# SMART Brief

T E C H N I C A L B U L L E T I N

**DATE:** Wednesday, January 09, 2008      **No:** SB-010908  
**TO:** Contractors & Distributors      **Page** 1 of 1  
**FROM:** Metro Technical Services Division  
**SUBJECT:** **Profiled Roman Bird-Stop Installer Correction Steps**

## Profiled Roman Bird-Stop Installer Correction Steps

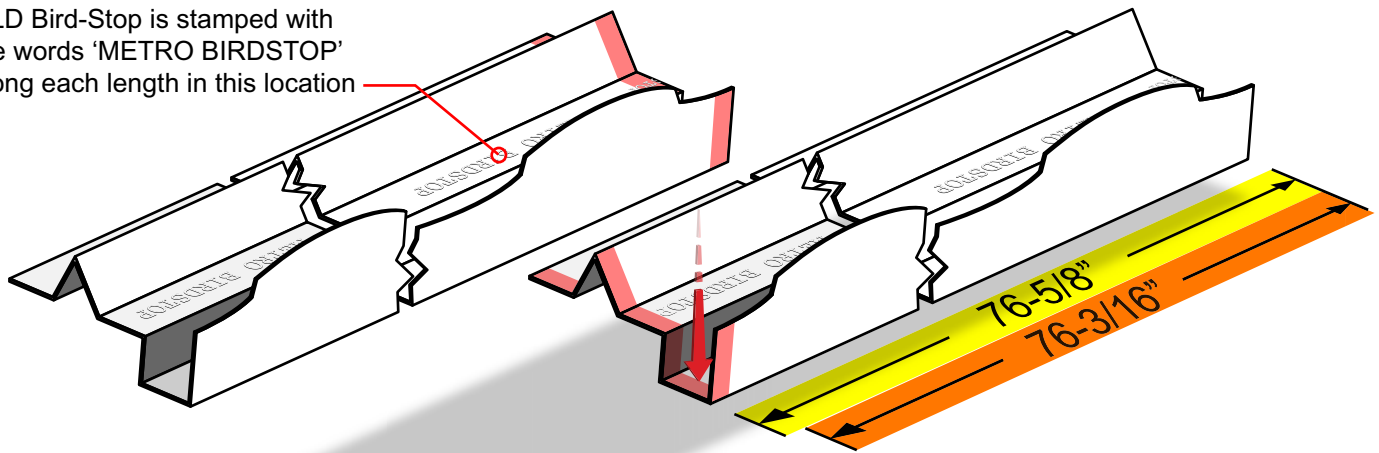
**The 'Old' Roman Bird-Stop measures 76-5/8" long and is installed by 'Lapping' each piece a 7/16" providing an exposure of 76-3/16.**

**For long Fascia lengths, as a spot-check, the measurement from the center of the 1<sup>st</sup> Bird-Stop Over-Pan (Hump) section to the center of the 1<sup>st</sup> Over-Pan on the sixth (6<sup>th</sup>) Bird-Stop piece measures **382-inches (31'-10")**.**

OLD Bird-Stop is stamped with the words 'METRO BIRDSTOP' along each length in this location

"Old" Bird-stop Measurements	
	Overall Length
	Exposure Length
	Lap Length
